METHOD STATEMENT REVIEW

JBA Project Code 2022s0454
Contract
Client
Day, Date and Time
Author Kevin Haseldine
Subject Helios Solar Farm FRA methodology review

JBA Consulting was commissioned by the Environment Agency in Spring 2023 to comment on the suitability of a modelling methodology for a Flood Risk Assessment (FRA) associated with a proposed solar farm near Selby in East Yorkshire. The methodology was developed by Aegaea on behalf of Enso Energy.

Figure 2: Datasets used to define the water level profile on the Humber estuary and its tidal tributaries

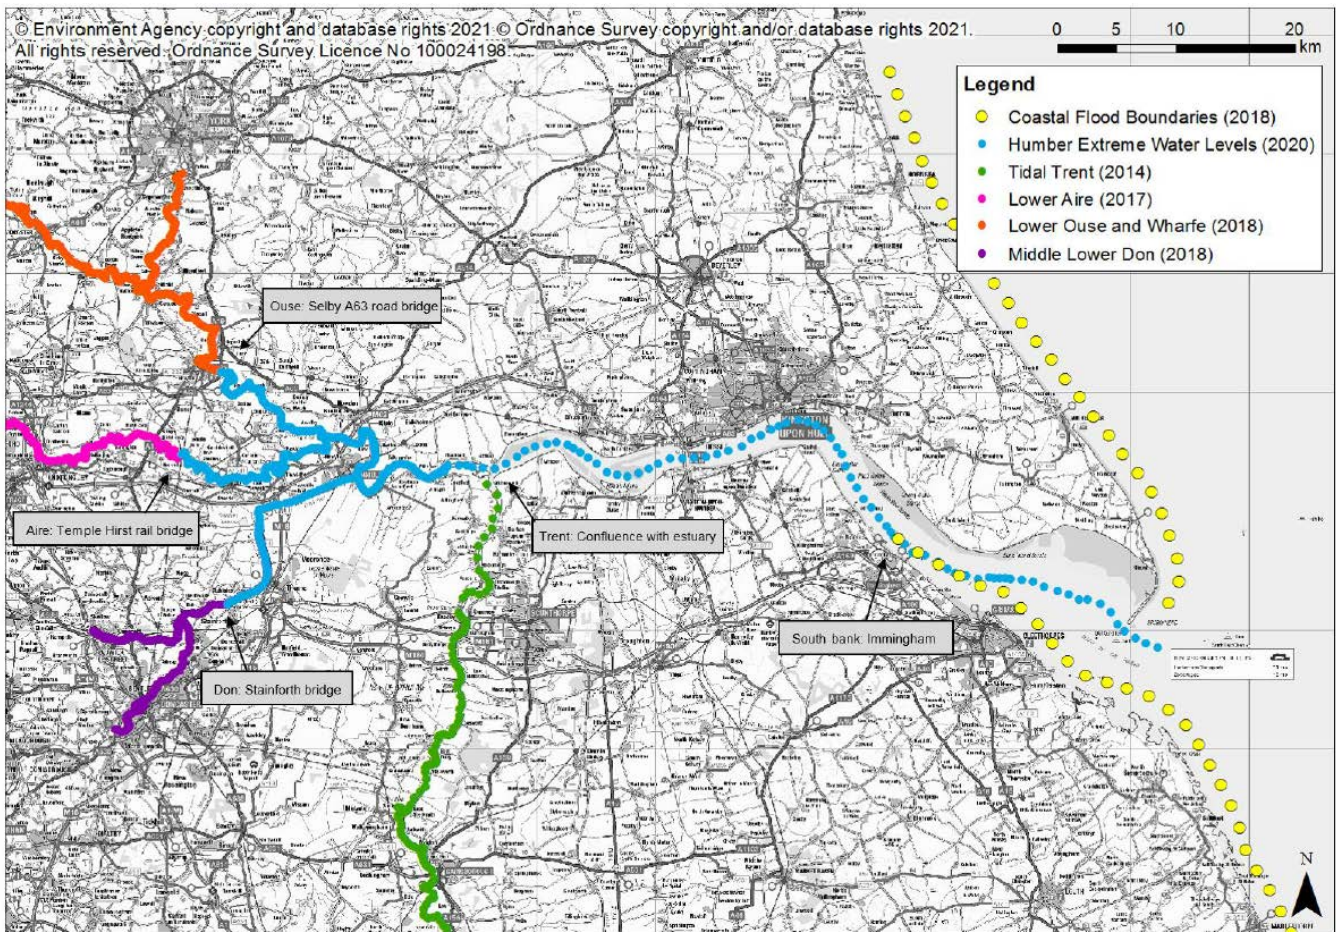
Both models are detailed and include good representation of the site of interest and may be suitable for use. However, the methodology fails to acknowledge the existence of the Humber 2100+ Extreme Water Levels¹ (HEWL) project. This was completed in 2020 by the Environment Agency and saw major revisions undertaken to the joint probability analysis (i.e., assessment of the likelihood of concurrent fluvial / tidal or fluvial / fluvial events), applying new boundary conditions to an estuary-wide 1D model. A summary HEWL report includes a map showing which models / datasets offer the best representation of extreme water levels for different areas with the Humber Estuary. This is shown below in Figure 2; the proposed solar farm site lies within a reach where HEWL results should be used.

The FRA project should make use of the HEWL project. Whilst the Upper Humber and Lower Aire model are likely to include more detail in terms of local topography compared to the HEWL 1D only model, the HEWL supersedes the boundary conditions of these older models. It is recommended that Aegaea revisit the modelling methodology with the HEWL included. The update should consider the relevant merits of each of the three models / projects and identify how each can be used to offer the best representation of flood risk at the site.
